ADDRESS: 2100-02 LOCUST ST

Proposal: Legalize windows; install four historically correct windows

Review Requested: Final Approval

Figure 4: Detail of the bow window before (above) and after (below) replacement.

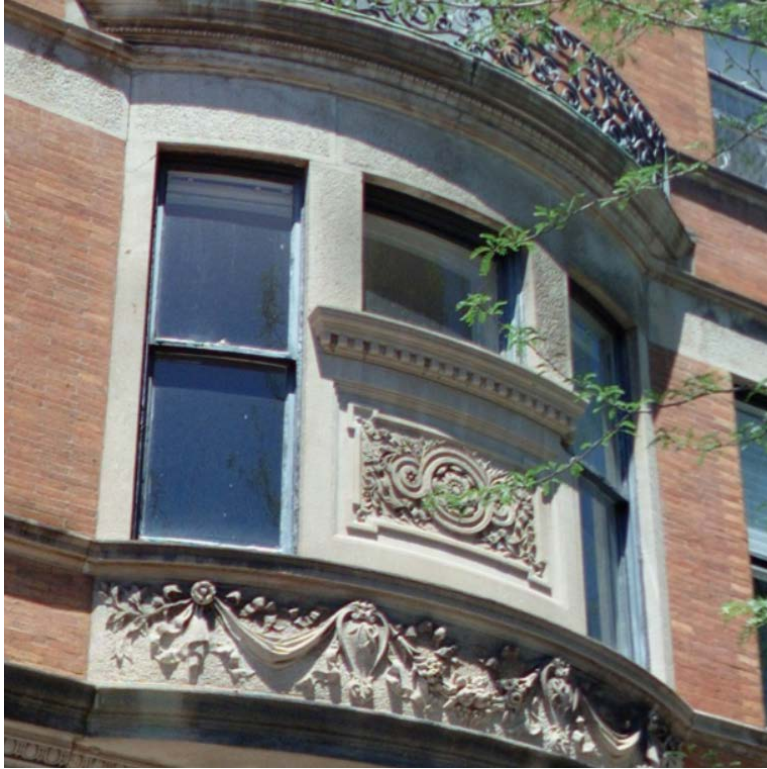
This application proposes to legalize all but four windows: three historically curved windows in the bow window at the second-floor, 21st Street elevation, and an arched one-over-one window at the first floor of the 21st Street elevation which was replaced with two double-hungs and a transom window.

STAFF RECOMMENDATION: Approval of the restoration of the four windows, but denial of the legalization of the remaining windows, pursuant to Standard 6.

NOTE:
TYPICAL WINDOWS THAT ARE NOT THE BOWED
OR ARCHED WINDOW ARE TO REMAIN AS IS

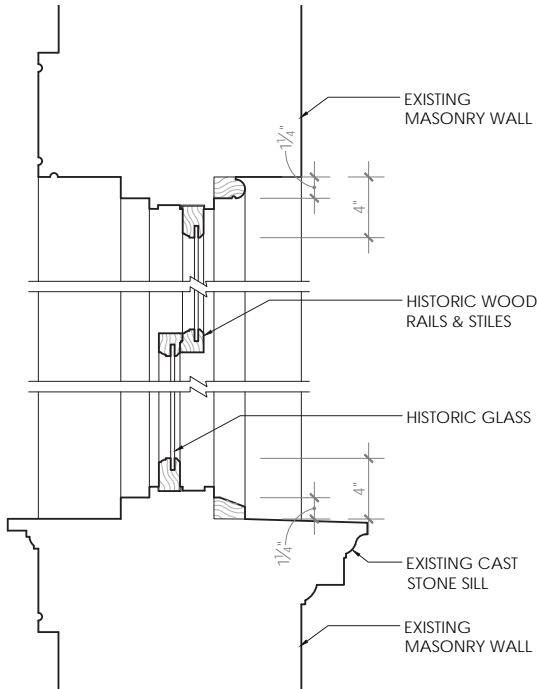
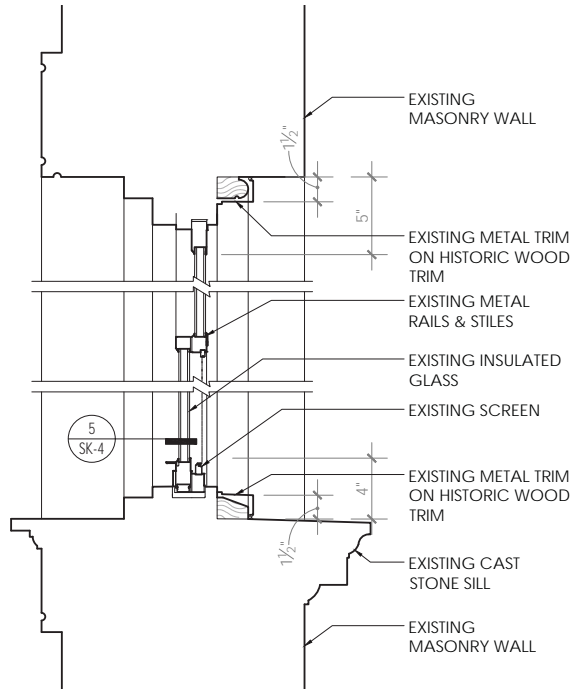
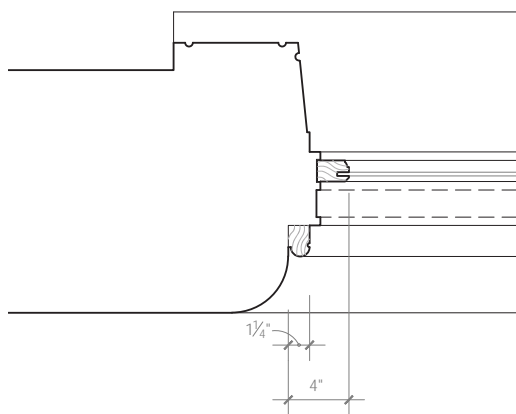
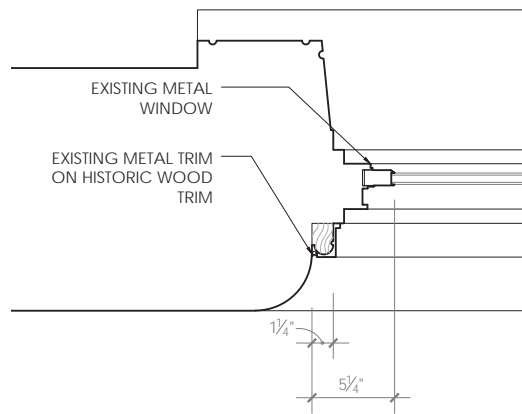
The application claims that the basement windows, which were historically two-over-two, double-hung wood windows, are concealed from the public view. The staff contends that the basement windows are, in fact, highly visible, owing to the height of the base. On the Locust Street elevation, the tops of the basement windows are nearly six feet above the sidewalk, and on the S. 21st Street elevation, the tops of the windows vary from four and a half feet to five feet above the sidewalk (see below).

We would request that the windows at the basement level, which are also incorrect in type and material (they were changed from double hung to sliders), be allowed to remain as they are less visible behind original wrought iron screen, and that the remaining 24 windows, which are the correct type but wrong material, be allowed to remain.
